Response to the Reviewers' Comments

The authors would like to thank the reviewers for the precious comments and suggestions on the technical contents and presentation of our manuscript “Runtime Power Management of Battery Electric Vehicles for Extended Range with Consideration of Driving Time,” submitted to IEEE Transactions on Very Large Scale Integration (TVLSI.) This revised manuscript has been greatly improved thanks to the reviewers’ invaluable advices. We have revised the manuscript faithfully following the reviewers’s comments. We include the newly added or significantly modified parts in the revised version of the paper also in Response to Reviewers. We highlight the important technical content changes and set those parts in a red color in the revised paper.

Fig. 2: (a) Range-speed experimental data for Chevrolet Bolt [36] and (b) comparison with simulation results of the proposed EV power model.

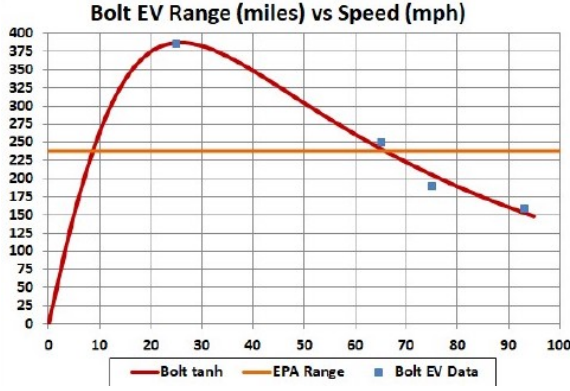
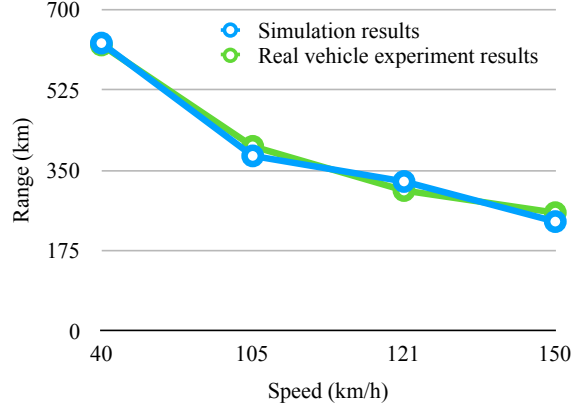
R1-C2 It is not clear how to validate the power model of EV. As the author mentions that accuracy of power model is quite important, it is good to see the power model in this paper can be validated by some real measurement results.

Here goes how we extracted correct coefficients of the EV power equation. We use a vehicle simulator that supports EV as well, ADVISOR, to extract the coefficients of new vehicles starting from known vehicle specifications such as the aerodynamic resistance, rolling resistance, curb weight, and so on. Such data is often published in the users' manual, website and so forth. We further use the vehicle performance data such as the top speed, maximum acceleration, and so on, which are also available on the manuals and website. We iteratively run ADVISOR and derive the model coefficients so that all the known values match among each other. We evaluate the model accuracy with the range-speed real vehicle experiments as shown in Fig. 1(a), which has been published by [32], [33], [34], [35], [36]. We further refine the coefficients until all the available data values match well. Finally, the derived EV power model well matches with the range-speed experimental data as shown in Fig. 1(b) as well as the top speed and maximum acceleration, setting the aerodynamic resistance, rolling resistance, curb weight, etc. with the known (fact) values. The errors of the range-speed simulation is merely 1.4%, the time to approach 60 mph at departure is 7.8%, and the top speed is 3.0%, respectively. We revised the manuscript adding the following paragraph with a new figure in Section III-A on page 3 and 4.

We use ADVISOR to extract the model coefficients of new vehicles starting from known vehicle specifications such as the aerodynamic resistance, rolling resistance, curb weight, and so on. Such data is often published in the users' manual, website and so forth. We further use the vehicle performance data such as the top speed, maximum acceleration, and so on, which are also available on the manuals, commercials and websites. We iteratively run ADVISOR and derive the model coefficients so that all the known data values match among each other. The model coefficient extraction result shows as in Fig. 1. The normalized root-mean-square (RMS) deviation is 5.1%. Table I summarizes the model coefficients of (5) for Chevrolet Bolt.

We further evaluate the model accuracy with the range-speed real vehicle experiments as shown in Fig. 2(a) to confirm the derived power models are close enough to the real vehicle measurement data [32], [33], [34], [35], [36]. We refine the coefficients until all the available data values match well.

As a result, the derived EV power model well matches with the range-speed experimental data as shown in Fig. 2(b) as well as the top speed and maximum acceleration setting the aerodynamic resistance, rolling resistance, curb weight, etc. with the known values. The errors in the range-speed simulation is merely 1.4%, the time for 0-to-100 km/h error is 7.8%, and the top speed error is 3.0%, respectively.

Fig. 13: Comparison of EDP for various energy-aware-velocity planning methods.

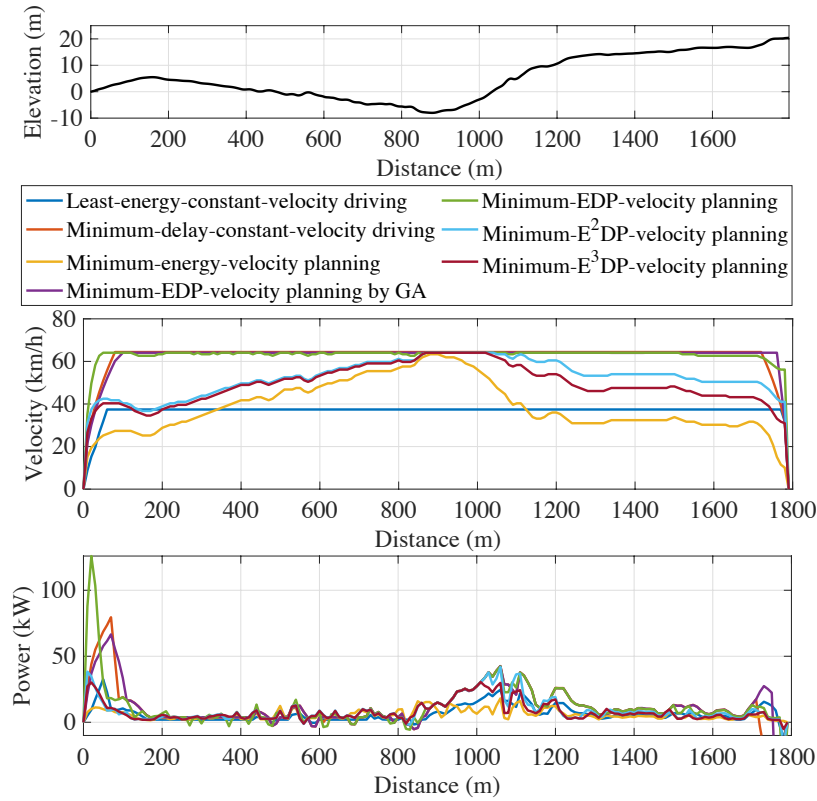
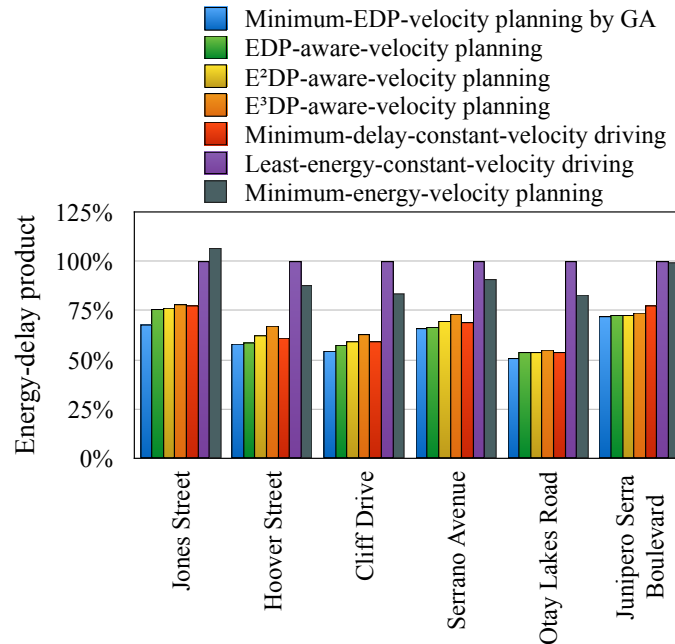
R1-C3 The optimality of the proposed scheduling algorithm is unclear. The author should add several paragraphs to discuss this topic. It is also to see the comparison baseline is well accepted to show the advantage of the proposed algorithm.

As the proposed solutions for EDP -, E^2DP - and E^3DP -aware-velocity planning are not optimal, we perform validation how close the proposed heuristics method is to the true optimal, comparing with the results of GA. We use the GA results as a golden reference to evaluate the optimality of the proposed heuristics. We divide a given driving route into multiple segments so that the solution of GA indicates a set of velocity values for each segment. We apply the vehicle acceleration and deceleration constraints so that the velocity difference at the boundary of two adjacent segments becomes close enough to avoid a jerky motion. We update the solution through crossover and mutation processes until the solution converges.

Fig. 12 summarizes EDP of the least-energy-constant-velocity driving, the minimum-delay-constant-velocity driving, the minimum-energy-velocity planning, the velocity planning with EDP , E^2DP and E^3DP as a metric on the road benchmarks and the minimum- EDP -velocity planning with GA. The proposed velocity planning results in up to 46.2% improvements of EDP compared with the least-energy-constant-velocity driving. The driving velocity on a flat road is faster than that of the least-energy-constant-velocity driving at the expense of relatively little energy to save driving time. Then, the velocity decreases when climbing the following uphill to spend less motor torque, which saves more energy.

In addition, EDP of the proposed EDP-aware-velocity planning is merely 4.3% higher than that of the true EDP-minimum-velocity planning on average. Through this results, we confirm that the results of the proposed heuristics are close enough to the true optimal solutions.

Fig. 11: Histograms of velocity and acceleration for the proposed energy-aware-velocity planning methods without an acceleration constraint (a) and (b) and with an acceleration constraint (c) and (d), respectively.

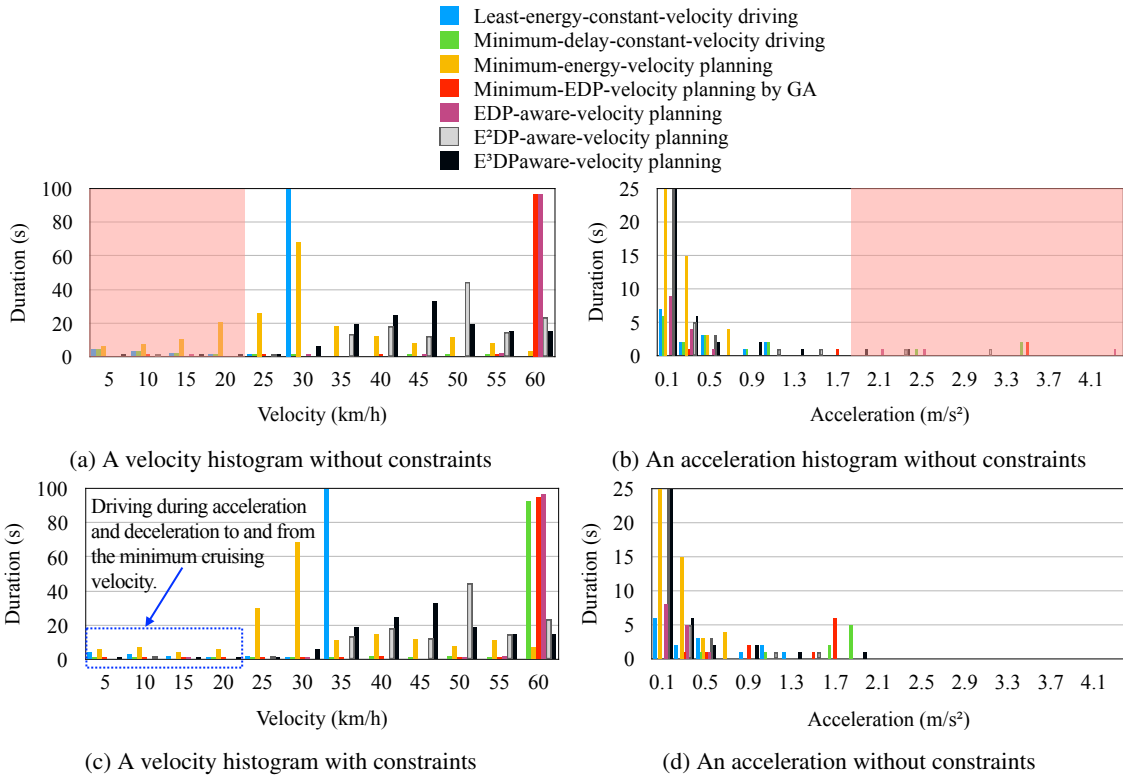
R2-C2 It would be good to have more discussion on the assumptions of the approach and the experiments, e.g., how much can the velocity be changed in practical scenarios without impeding traffic and causing unsafe situations (also depending on the road conditions and whether it is urban or rural environment I suppose). Currently, there only seems to be one constraint on not slower than 10 km/h.

Fig. 11(a) and (b) show two histograms of the driving schemes in Fig. 12, which do not have velocity and acceleration constraints. We avoid a cruising velocity lower than 25 km/h and an acceleration higher than 2.0 m/s^2 in this paper without loss of generality. The acceleration of 2.0 m/s^2 is the same as the maximum acceleration of compact cars designed to be used primarily used in urban areas (13 seconds of 0 to 100 km/h time).

Fig. 11(c) and (d) shows the velocity and acceleration histograms with the constraints. Once we run the DP for the first time without constraints, we analyze the histogram, adaptively determine the minimum cruising velocity and maximum acceleration constraints, and run DP again. We keep the same constraints for online recomputation whenever unexpected interrupts occurs.

We also enforce the minimum acceleration not lower than 1.0 m/s^2 when the EV starts from a stop sign or a traffic light until the velocity reaches to the minimum cruising velocity not to bother traffic flow. The acceleration of a 1.0 m/s^2 exhibits 6 second delay to reach 25 km/h. The maximum speed is bounded by the speed limit of each road benchmark.

acceleration for the proposed energy-aware-velocity planning methods. Fig. 11(a) and (b) show two histograms of the driving schemes in Fig. 12, which do not have velocity and acceleration constraints. We avoid a cruising velocity lower than 25 km/h and an acceleration higher than 2.0 m/s^2 in this paper without loss of generality. The acceleration of 2.0 m/s^2 is the same as the maximum acceleration of compact cars designed to be used primarily used in urban areas (13 seconds of 0 to 100 km/h time).

Fig. 11(c) and (d) shows the velocity and acceleration histograms with the constraints. Once we run the DP for the first time without constraints, we analyze the histogram, adaptively determine the minimum cruising velocity and maximum acceleration constraints, and run DP again. We keep the same constraints for online recomputation whenever unexpected interrupts occurs.

We also enforce the minimum acceleration not lower than 1.0 m/s^2 when the EV starts from a stop sign or a traffic light until the velocity reaches to the minimum cruising velocity not to bother traffic flow. The acceleration of a 1.0 m/s^2 exhibits 6 second delay to reach 25 km/h. The maximum speed is bounded by the speed limit of each road benchmark.

Fig. 8: Altitude changes in the real road benchmarks.

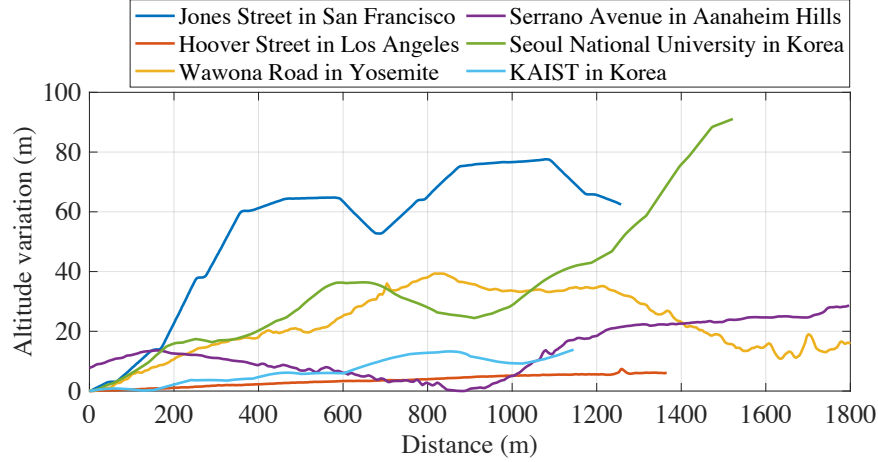
R2-C3 Related to the last point, it would be good to have more discussion on the road benchmarks, e.g., how they are generated and how representative they are. The optimization results significantly depend on road slope. It would be good to use a variety of real road segments for testing.

R2-A3 We appreciate the reviewer's comment and added six new real routes from various locations in California. The first three roads are in cities. Jones Street in San Francisco and Hoover Street in Los Angeles are two representative city landscapes such as hills and flat roads, respectively, and Cliff Drive in Santa Barbara is a mixture of those. The second two roads are in mountain areas: Serrano Avenue in Anaheim Hills and Otay Lakes Road in San Ysidro Mountain in California. The last road is Junipero Serra Boulevard connecting San Francisco and San Jose. The details of road data is summarized in Table II, and Fig. 8, which visualize the altitudes of the road benchmarks.
